How safe is the proposed Tehri dam to earthquakes

R. N. Iyengar

Tehri dam, the construction of which has been stopped presently at a height of 20 m, has been surrounded by controversies. This article explains the main issues related to seismic analysis and design. Since the valley, at the dam site, is too narrow, three-dimensional effects have to be accounted for in the design. Also, the peak ground acceleration of 0.22 g recommended by the expert committee appointed by Govt. of India needs considerable upward revision.

Figure 1. Cross section of valley at Tehri dam site.

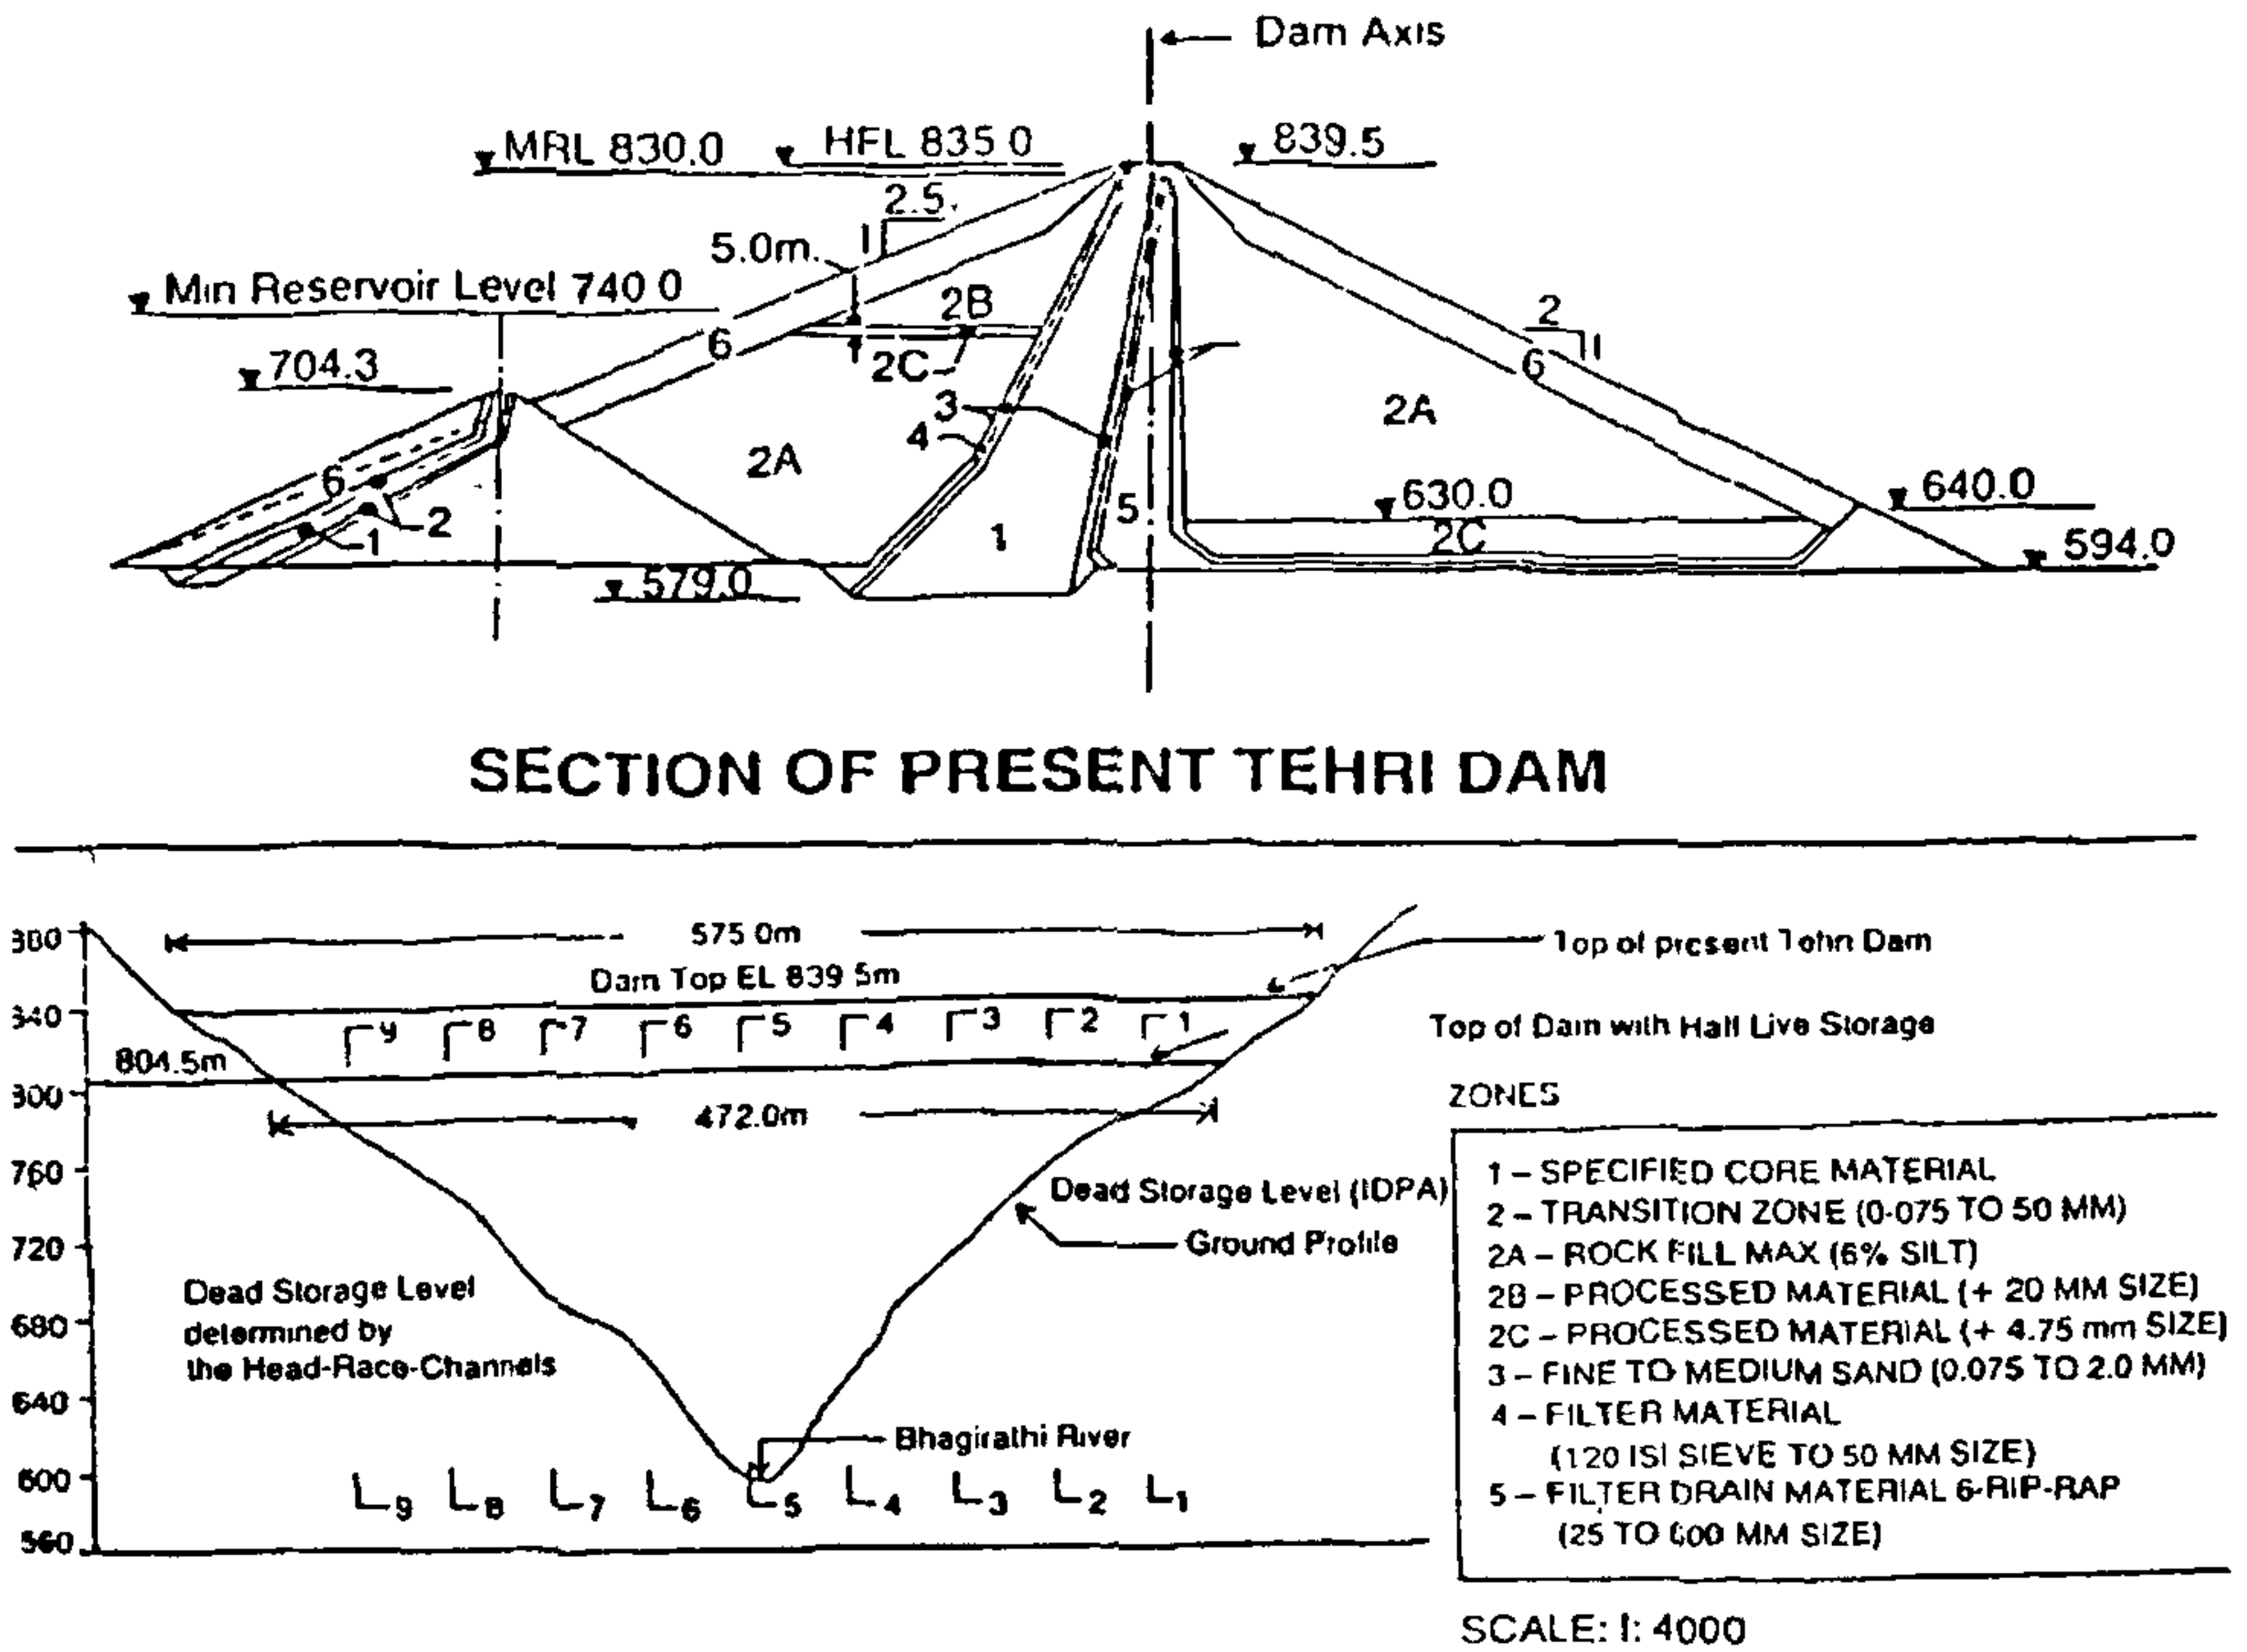
The reported natural periods in seconds are 2.272, 1.672, 1.476, 1.256, 1.087 and 1.104 for the central section. The corresponding figures for the abutment section are 1.504, 1.025, 0.952, 0.854, 0.753 and 0.640 seconds. These are presumably obtained by a finite element analysis of the section and are generally referred to as the two-dimensional values. The shear wave velocity $V_s = (G/\rho)^{1/2}$ for the dam material has been estimated to be 300–320 m/s. This gives from eq. (1) the first natural frequency at the central section to be $f_{1D} = 0.51$ Hz ($T_1 = 1.96$ sec). This frequency is understandably higher than the two-dimensional value of $f_{2D} = 0.44$ Hz, since in the latter case, not only the US-DS flexibility but also the vertical flexibility of the dam is included. However, neither of the theories is applicable at Tehri. The dam being constructed in a triangular valley with L/H nearly equal to 2, there will be severe stiffening due to the canyon walls, which calls for a three-dimensional analysis. The two-dimensional analysis can be justified only in the 'plane strain' case of the classical Theory of Elasticity. For this to happen, the (L/H) value should be more than six. The canyon

Figure 2. Effect of canyon geometry on the fundamental natural period (Gazetas⁹).

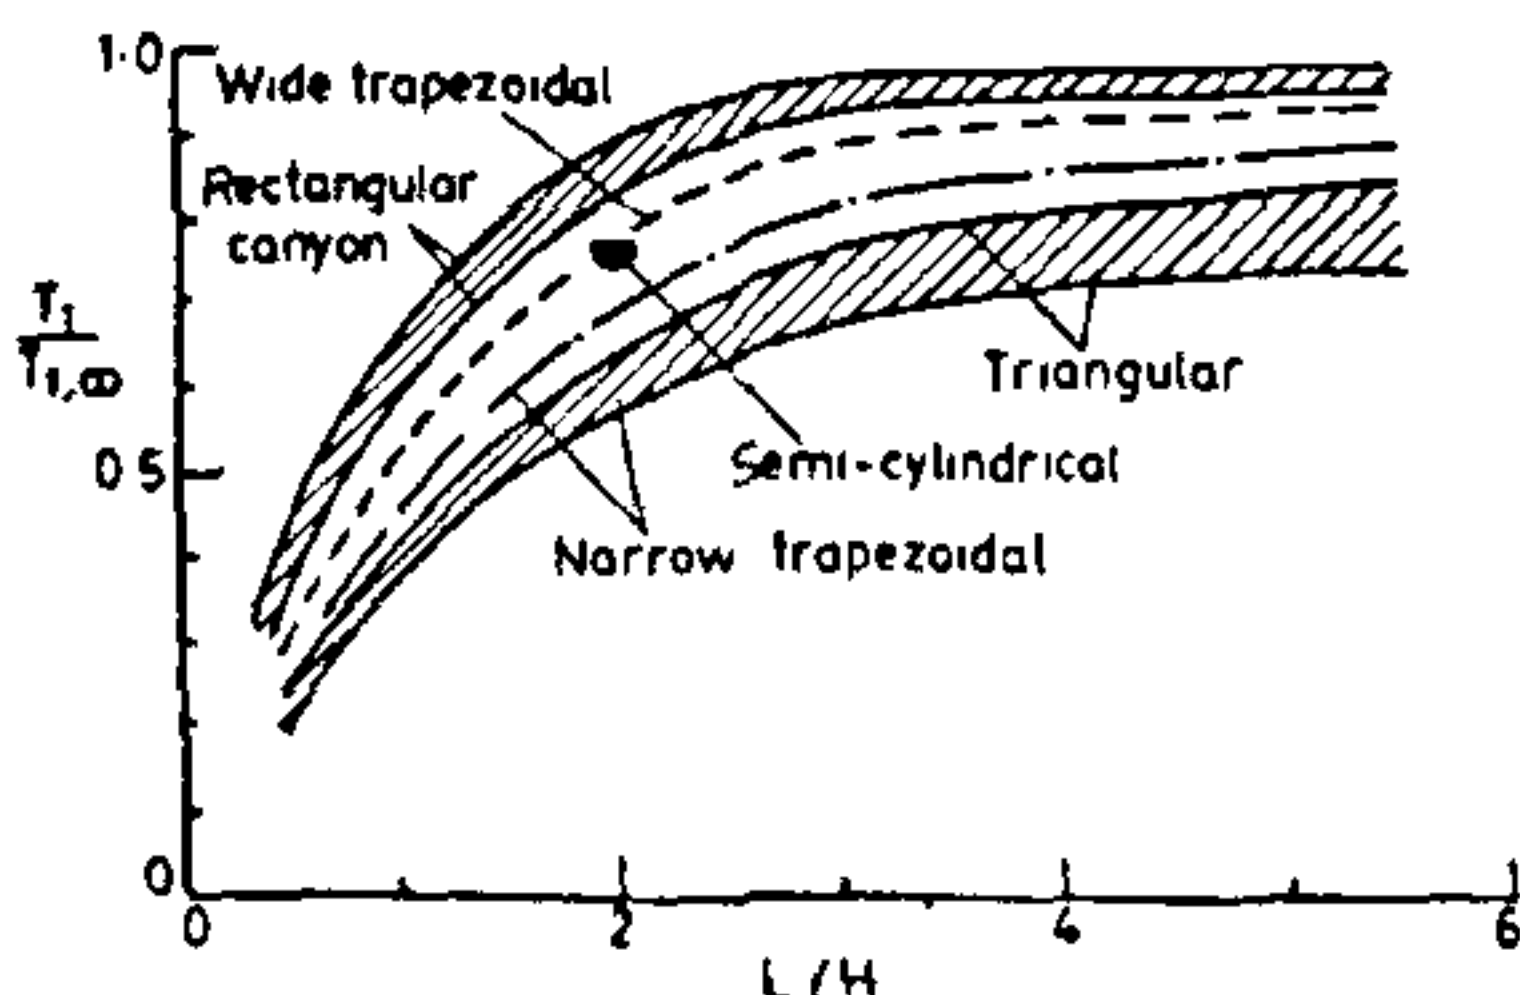
From the above considerations it appears that the Tehri dam (3-D) first natural frequency would be nearly equal to 0.8 hz (= 1.8/2.27). Furthermore, the section of the dam is not a neat triangle. At the mid section, the downstream arm is unusually short⁴. Also, the river bed

section and the abutment sections are geometrically dissimilar. Thus, the actual fundamental period of the dam is likely to be 1–1.25 seconds, which is roughly half the current reported value. The frequency spectrum of other modes which will contribute under an earthquake, are likely to extend at least up to about 0.3–0.5 seconds (2–3 hz). Thus, the view held by some engineers that the dam is very flexible and hence will not respond severely to the Himalayan earthquakes which have their energy concentrated in the high frequency end of the design seismic acceleration response spectrum, is not justified. The Soviet report¹² on the behaviour of the Tehri dam under the Gazli accelerogram does mention about the canyon effect but is obscured by the fact that only a 2-D analysis has been done that too on a section which differs from the one exhibited as the river bed section in the THDC report⁴. In any case only one component of the horizontal accelerogram has been used indicating that no longitudinal response studies were done, for understanding possible development of transverse cracks.

Figure 4. Accelerogram recorded at Koyna dam (1a gallery) for earthquake of 11 December 1967 (time of origin $t_0 = 04:21:17$ IST).

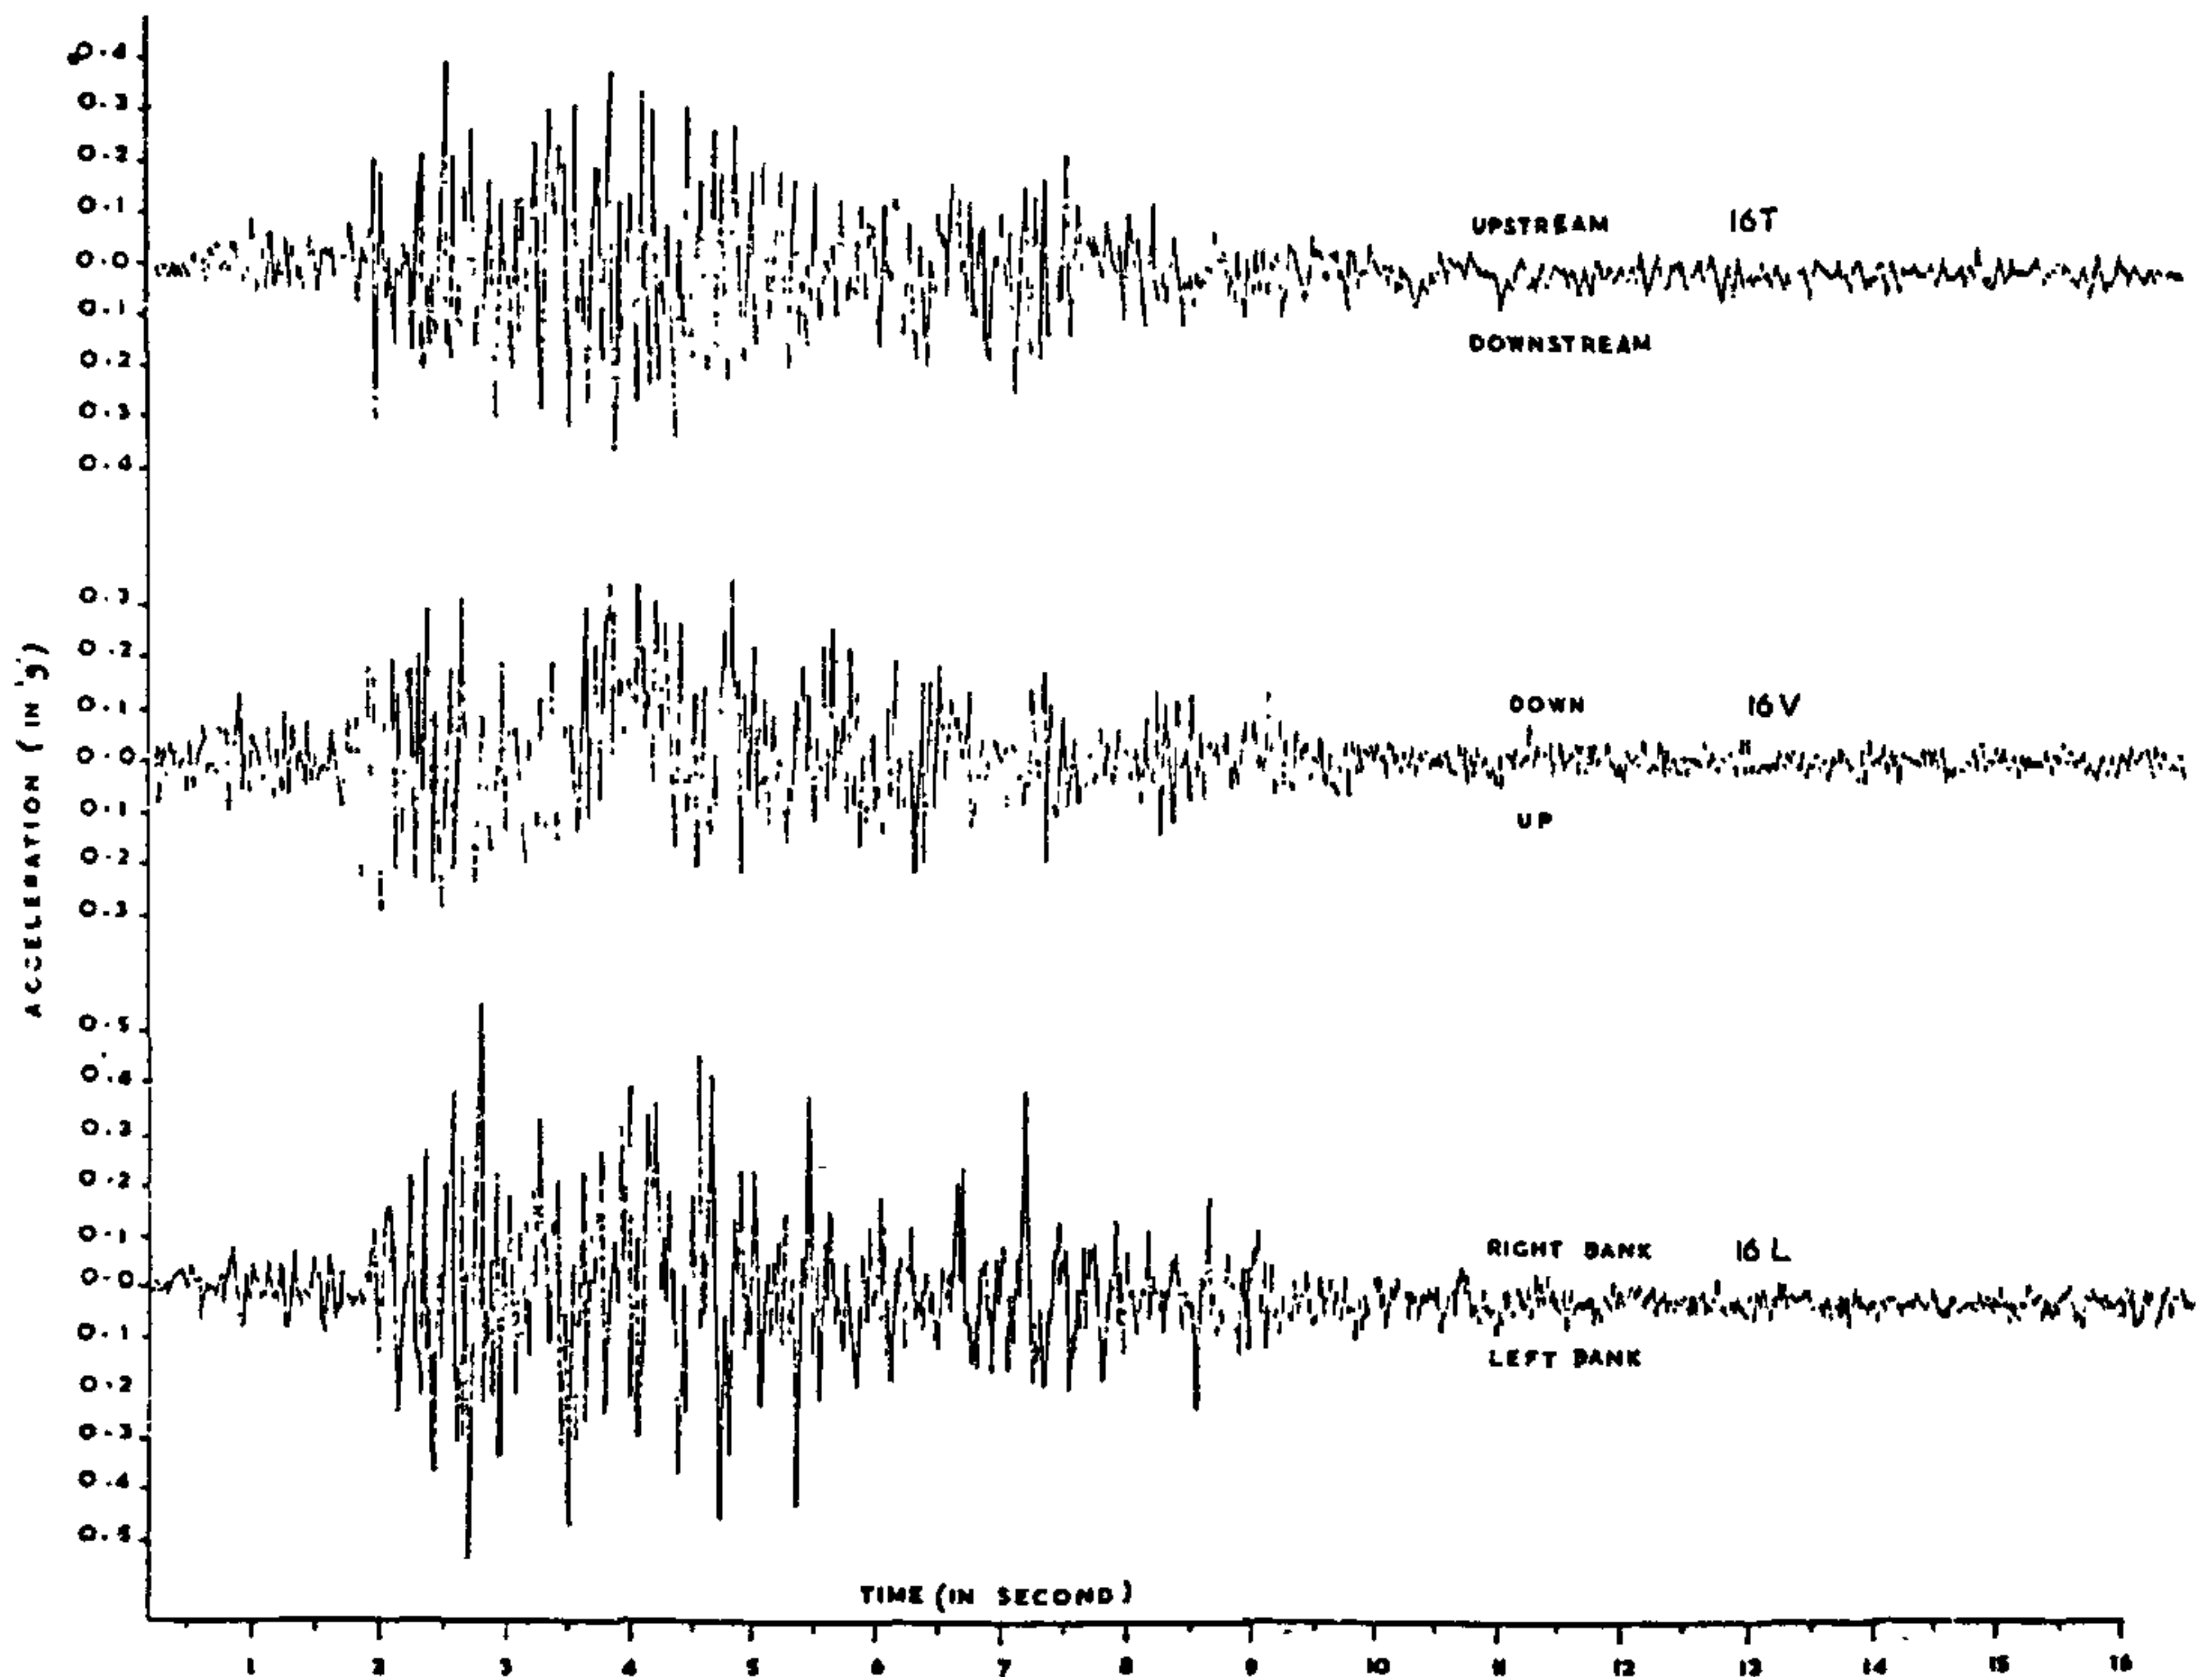
A typical strong earthquake accelerogram record is shown in Figure 4. A high isolated peak ($PGA \approx 0.5$ g) is clearly visible. The proponents of the EPGA concept will say that the effective PGA is however less than this value. Their main argument is to show that the response spectrum of the accelerogram would be relatively insensitive in the frequency range of interest, to variations in the isolated PGA value. This of course is a verifiable fact, but this is no proof that observed PGA values should be disbelieved. It is a reflection of the strong filtering property of the underdamped oscillator, which is not much affected by the PGA which sits as a high frequency kink. This cannot be the

basis for wishfully reducing a crucial seismic parameter such as PGA. If we have to follow the scientific approach of observation, analysis and inference, the instrumental recordings have to be believed and retained for whatever they are worth. The PGA as explained previously is a bench-mark with which the spectral shape will get multiplied to arrive at the MCE spectrum. Since EPGA is always less than PGA, acceptance of this concept could be construed as *erring on the unsafe side*. For small amplitude earthquakes, when the structural response will be linear, curtailing a high peak may not matter. But the same is not true with nonlinear systems. A rockfill dam like Tehri is highly nonlinear when the slope failure modes are analysed. Even though we do hear the concept of EPGA floated by some individuals now and then at conferences and meetings, it is not a universally accepted philosophy of design in earthquake engineering. The THDC report (p. 5) mentions about the PGA of 0.56 g recommended by NGRI and the EPGA of 0.25 g recommended by the DEE (Department of Earthquake Engineering, University of Roorkee). Further, in a valiant effort to justify the EPGA, the report says, 'For proper understanding of the difference between PGA and EPGA knowledge of dynamic analysis for dams is essential'. A typical case of putting-the-cart-before-the-horse syndrome! Further, the THDC report disappoints, to put it mildly, in telling, 'In a real accelerogram, the value of peak ground acceleration may be reduced without effecting its damage potential as the latter is not dependent upon single peak'. If the damage potential is not affected by the single high peak, as made out, why not allow it to be there, at least in public interest?
